**Re: CRS Site Group Comments on U.S. EPA's Proposed Plan
for the CRS Site in Elyria, Ohio**

CRS SITE GROUP COMMENTS ON
U.S. EPA'S PROPOSED PLAN FOR THE
CHEMICAL RECOVERY SYSTEMS, INC SITE IN ELYRIA, OHIO
DATED JULY 11, 2007

CRS SITE GROUP POSITION PAPER SOURCE REMOVAL OPTIONS IN THE NORTHWEST CORNER

CRS SITE GROUP TECHNICAL MEMORANDUM GROUNDWATER DISCHARGE

FIGURE 1
EXCAVATION LIMITS

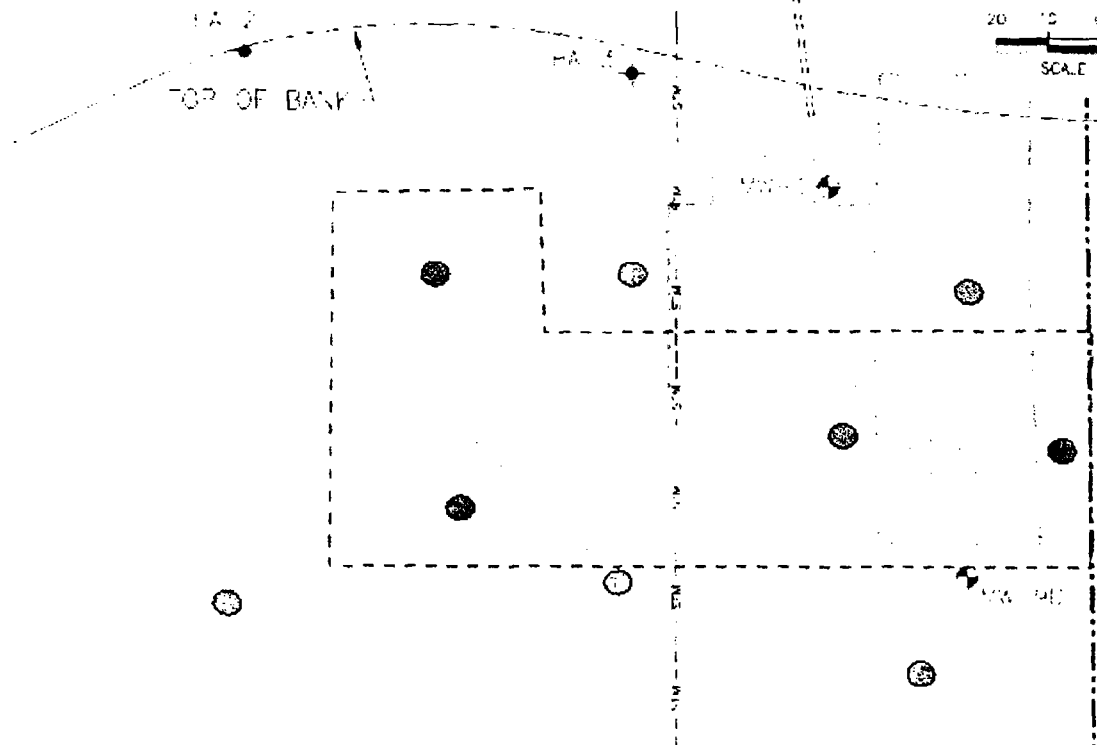
The Group suspects, however, that the more effective and more timely source removal option will be a targeted excavation with predetermined cut-lines horizontally and vertically. U.S. EPA indicated that a site specific target level (SSTL) of 14 mg/kg for trichloroethylene (TCE) would be used in the northwest portion of the site to establish horizontal and vertical excavation cut lines. EPA used the existing chemical soil data in the RI to estimate that vertical excavation would achieve 14 mg/kg TCE or less after removing the first four feet of soil in the northwest corner. Figure 1 reflects The Group's analysis of existing data to estimate the horizontal extent of soils in the northwest portion of the site with TCE concentrations greater than 14 mg/kg (the soils surrounding GP-37, GP-38, GP-39, and GP-40). Based on EPA's proposed excavation depth of four feet, the volume of soils in the defined area to be excavated is estimated to be 1,200 cubic yards. This does not include the isolated elevated TCE reading at GP-45 (77 mg/kg), which could be excavated separately to four feet.

As the excavation area is surrounded by the areas of the Site that are to receive a four (4) foot soil cap, the excavation area would require additional material and soil for backfill and grading purposes. EPA agreed to allow clean demolition debris from the buildings on site as the material for backfill in this area. The soil added to cap the northwest corner area, however, should be an engineered fill consisting of a layer of low permeability, clayey type soil to minimize future infiltration through the soil matrix in this area. Again, partial excavation with a more permeable soil cap is less protective of human health and the environment than the preferred enhanced soil cap remedy in the approved RI/FS.

<p>NOT FOR BIDDING OR CONSTRUCTION</p>	
<p>PARSONS</p>	
<p>CHEMICAL RECOVERY SYSTEM SITE ELYRIA, OHIO</p>	
<p>GROUNDWATER FLOW MAP 12 NOVEMBER 2003</p>	
<p>3-10</p>	<p>1</p>

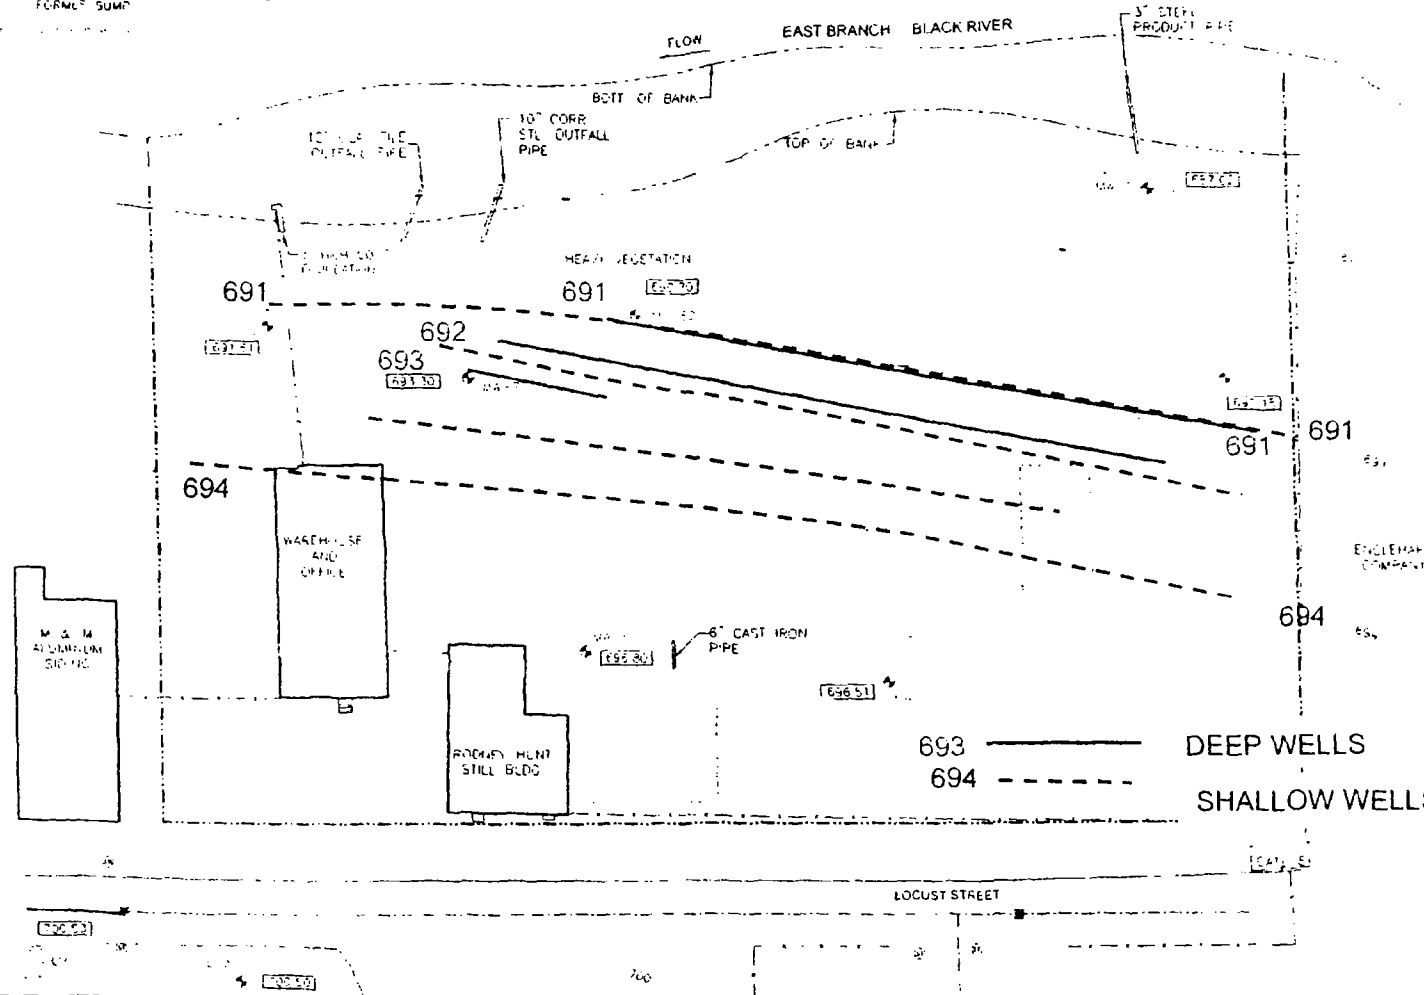
As discussed in detail below, available data support the conclusion that groundwater from the site flows to the river. A hydraulic gradient evaluation was performed to identify potential vertical migration at the referenced site. Using water level data for November 12, 2003, separate contours were constructed for the deep wells (MW-7D, ME-8D and MW-9D) and the shallow wells (MW-1, MW-5, MW-6, MW-16). The contours were constructed manually, using linear interpolation between pairs of wells. The contours are shown on Figure 3-10.

The map shows that the contours for the deep wells (solid red) are parallel to the contours for the shallow wells (dashed blue), which indicates that deeper groundwater flow is parallel to the shallow groundwater flow. The elevation 691 contour for the bedrock directly underlies the elevation 691 contour for the shallow wells. This shows that at the location of the contours, the potentiometric surface is vertical, which means groundwater flow is horizontal.

The elevation 692 and 693 contours for the deep wells are offset from the elevation 692 and 693 contours for the shallow wells. The offset indicates that at those locations, the potentiometric surfaces angle upwards, indicating an upward hydraulic gradient. For example, at well MW-7D, the groundwater elevation in the deep well is 693.3, while the approximate shallow groundwater elevation is 692.3.
